Kai Tak Water Quality

A new scheme needed to ensure clean water

March 2021

Original plan for cleaning up the approach channel

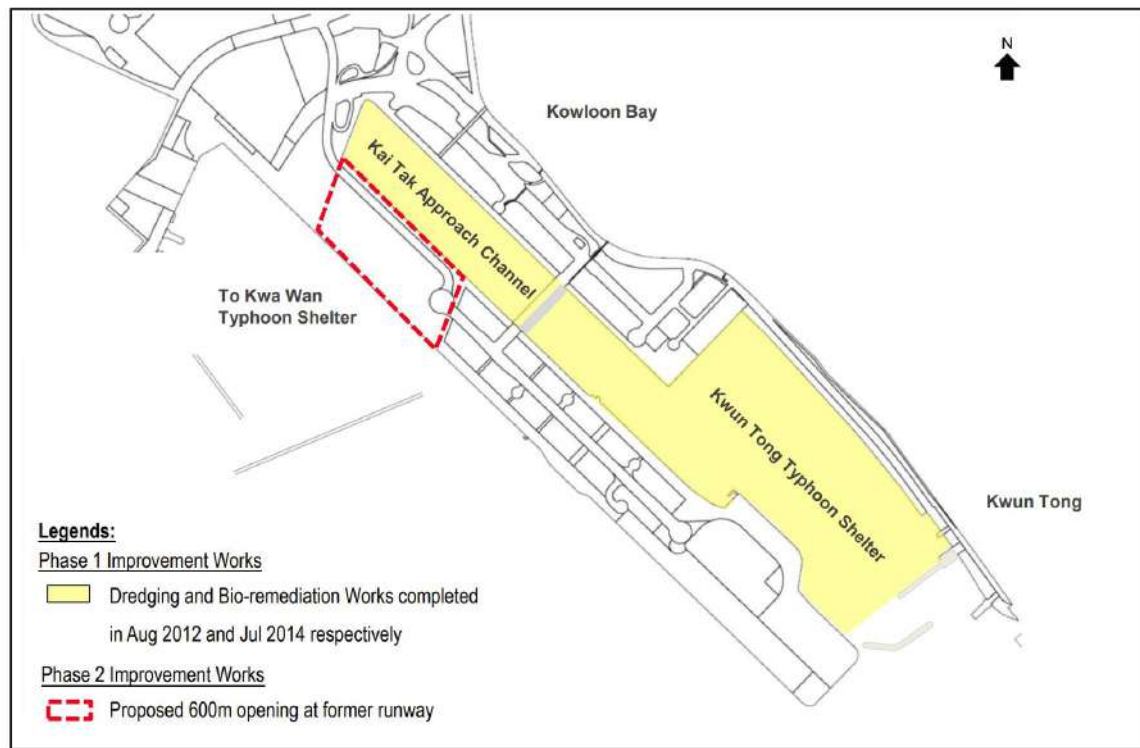
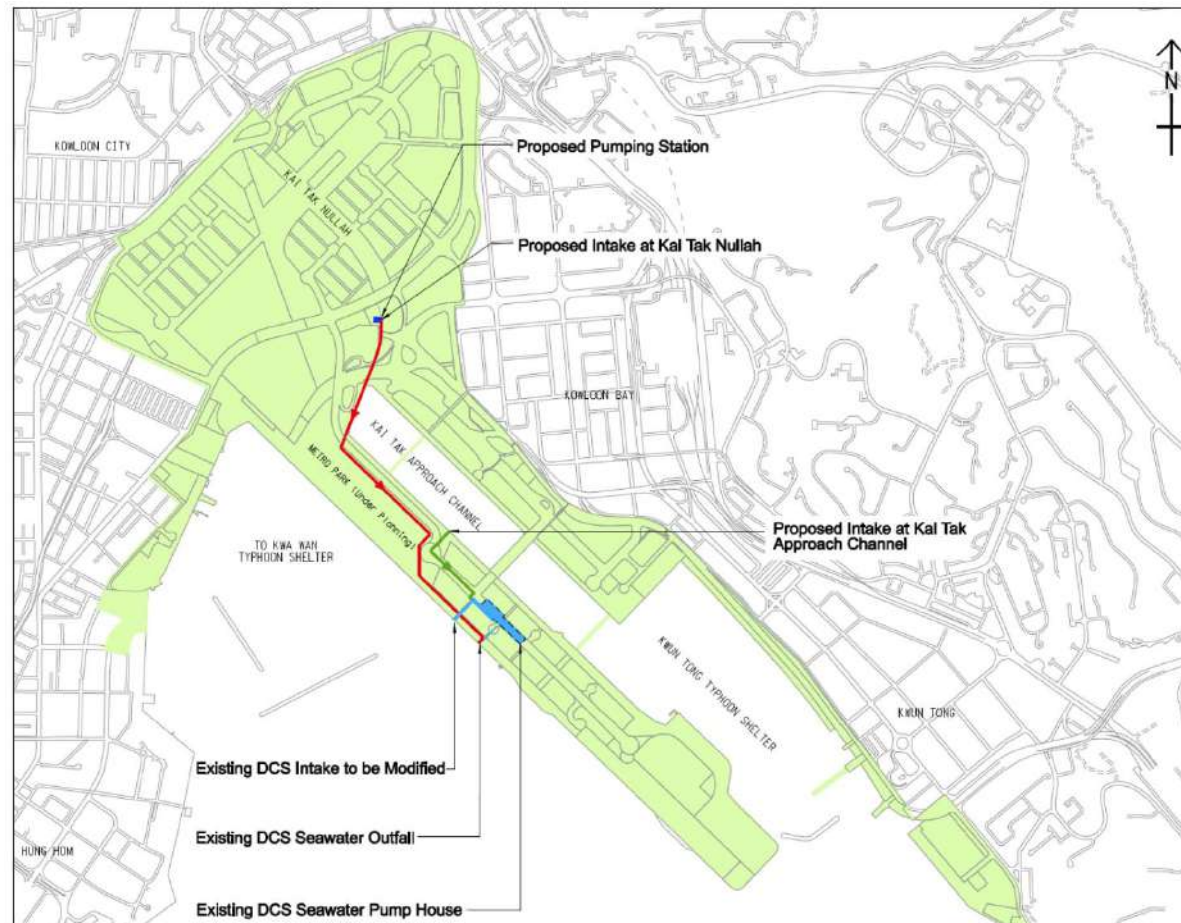
2015: A new interception and pumping scheme is adopted to replace the original proposed 600m opening at former runway to improve the water quality and odour control.

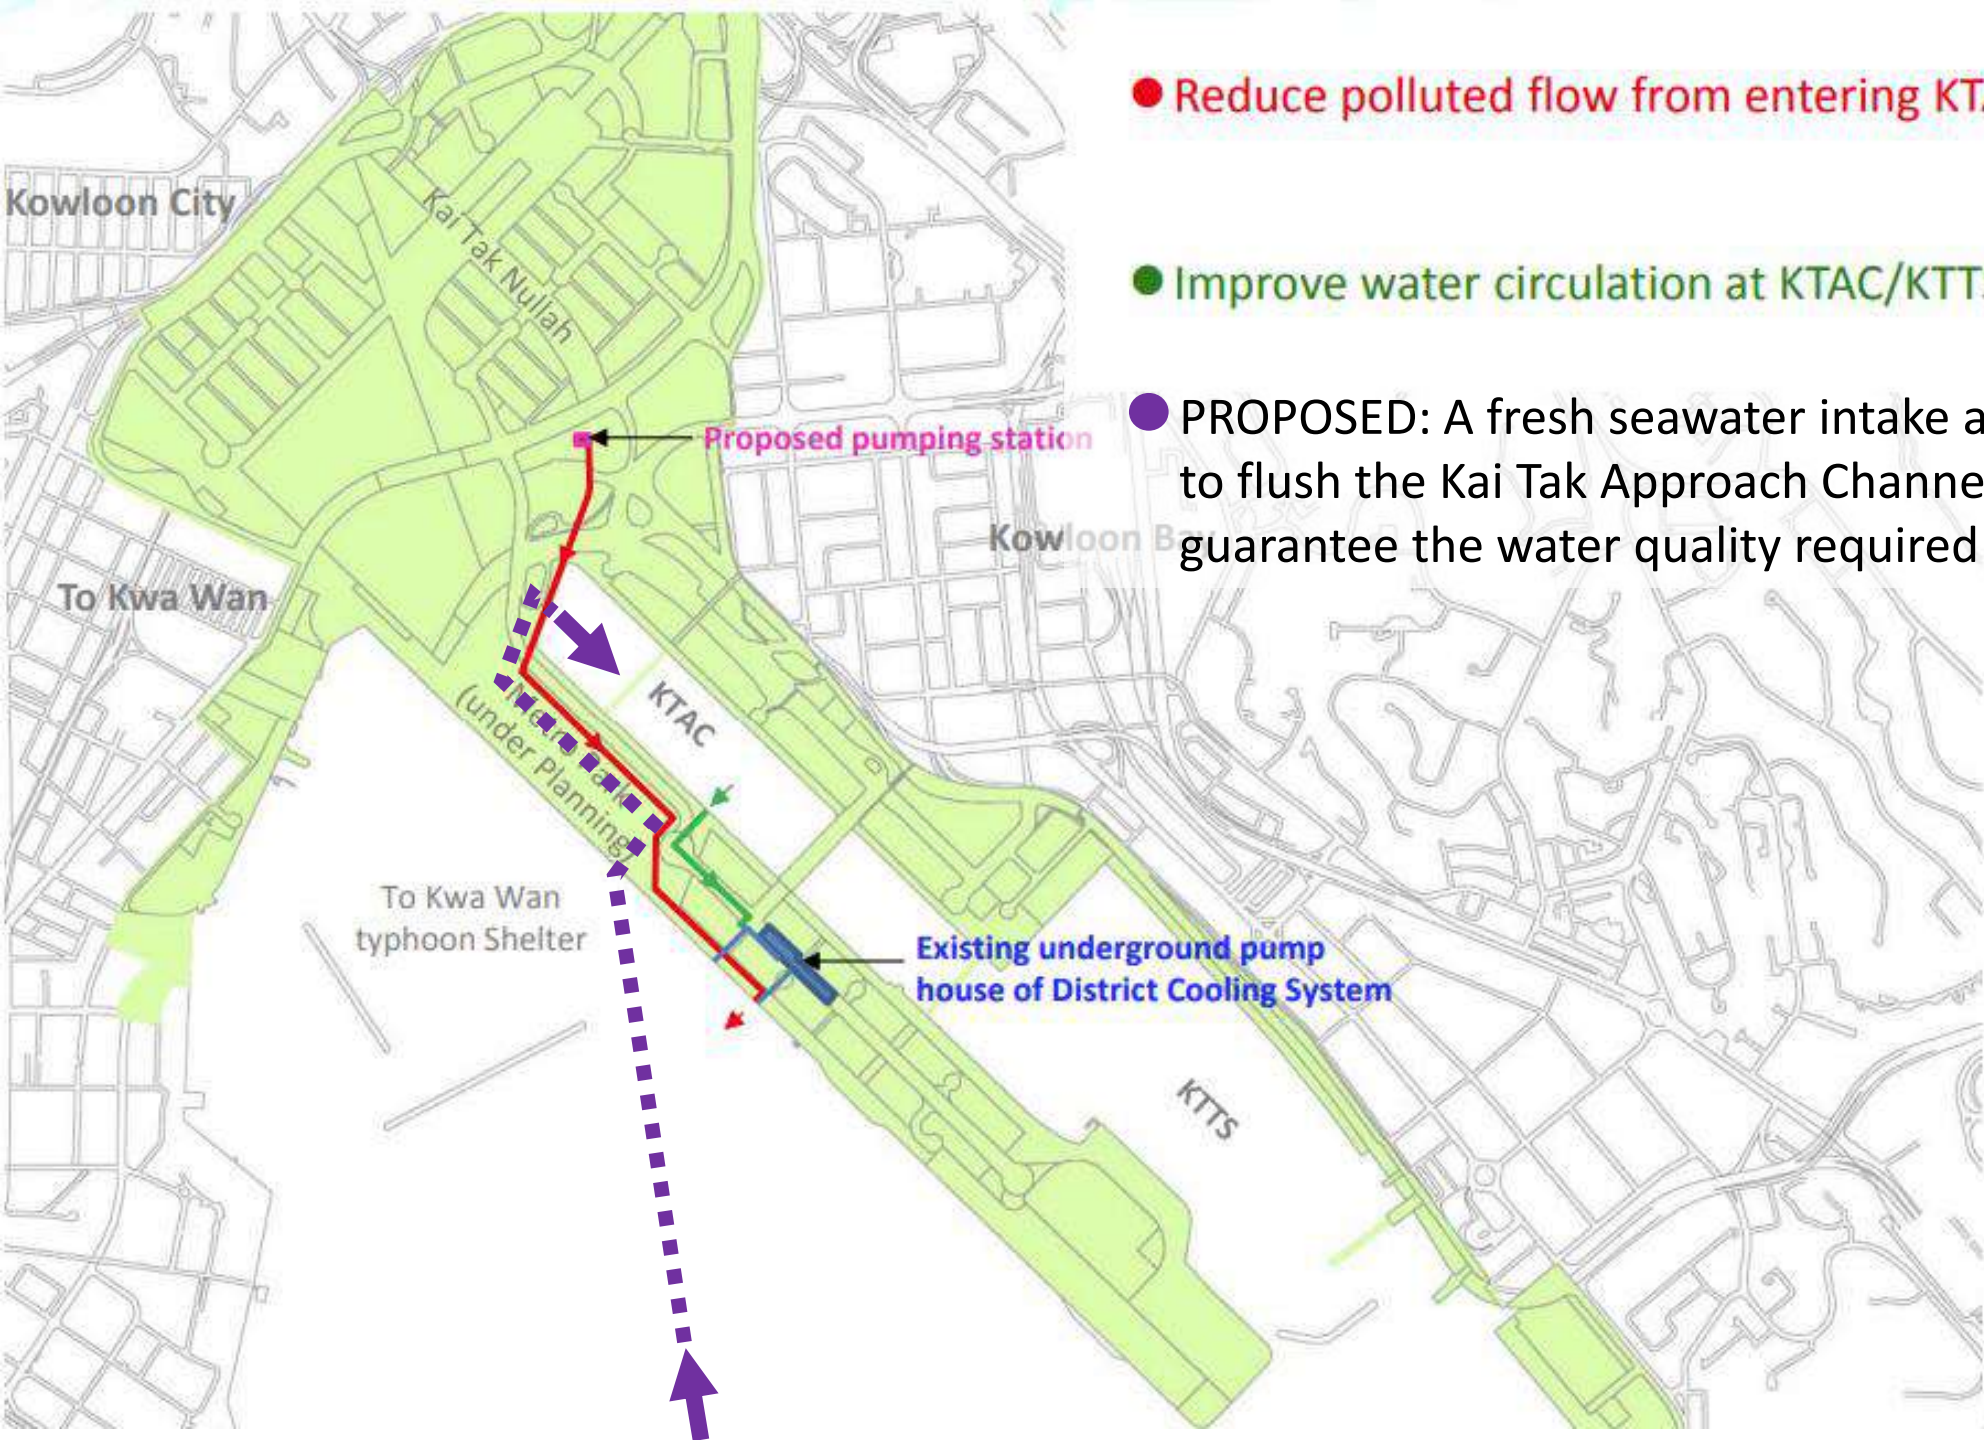
On 6 November last year, the Director of Environmental Protection expressed concern that “*it is doubtful whether the water quality at the upstream part of channel could (ever?) meet the E. coli requirement of “below 610 count/100ml” for secondary contact recreational uses.*”

That would be a major loss to the community. We call for a review of the planned schemes to ensure the water quality requirement for recreational uses. One option to consider is the installation of a system pumping fresh water from the harbour to the most-upstream part of the semi-enclosed waterbody to flush the channel as needed.

● PROPOSED: A fresh seawater intake and pumping system to flush the Kai Tak Approach Channel as needed to guarantee the water quality required for recreation.
